# **Technical Basis for Revision of the Pressurized Thermal Shock (PTS) Screening Limit in the PTS Rule (10 CFR 50.61)**

## **Appendices**

**U.S. Nuclear Regulatory Commission  
Office of Nuclear Regulatory Research  
Washington, DC 20555-0001**

Figure 1  
Cooldown Transients for Palisades

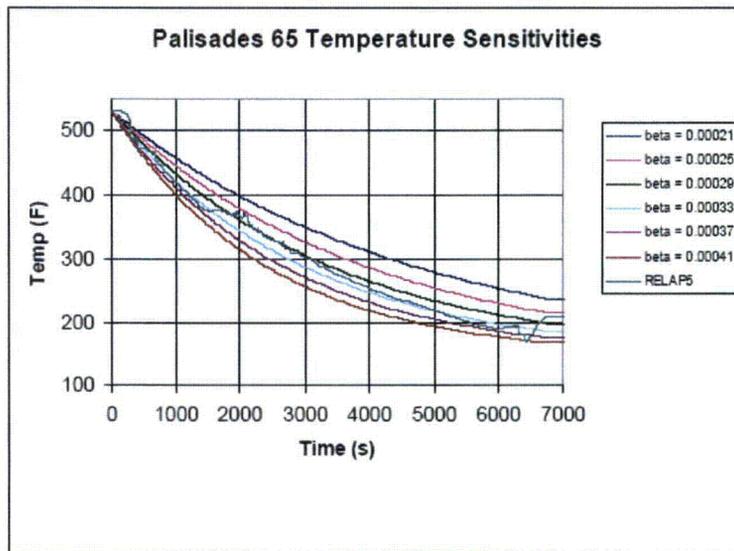
The cooldown rates examined are shown in Fig. 1, taken from the thermal-hydraulic sensitivity study by Bessette. The RELAP5 result was used as a basis and higher and lower values of the decay rate were obtained by using higher and lower values of  $b$ . This is a reasonable approach if the initial value calculated by RELAP5 is appropriate. The ranges of values of  $b$  chosen, however, yield less than a plus or minus 20% variation in the total downcomer temperature change. The ROSA tests show larger variations than this although it is not clear whether or not the average decay rate is higher or lower. Further, it is not clear how the figure was used; e.g., the given temperature time behavior is used for all the transients. This temperature range needs to be justified and how it is used needs to be explained.

How it was decided that the cooldown rate predicted by RELAP5 is the appropriate starting place is not clear. It seems that this would be a good place to use the results from the OSU testing as it was based on scaled studies. Doing so would give a “code independent” evaluation as well as an opportunity to further validate the code. An initial step might be to incorporate some of the OSU scaling study results (NUREG/CR-6731) into Figure 1.
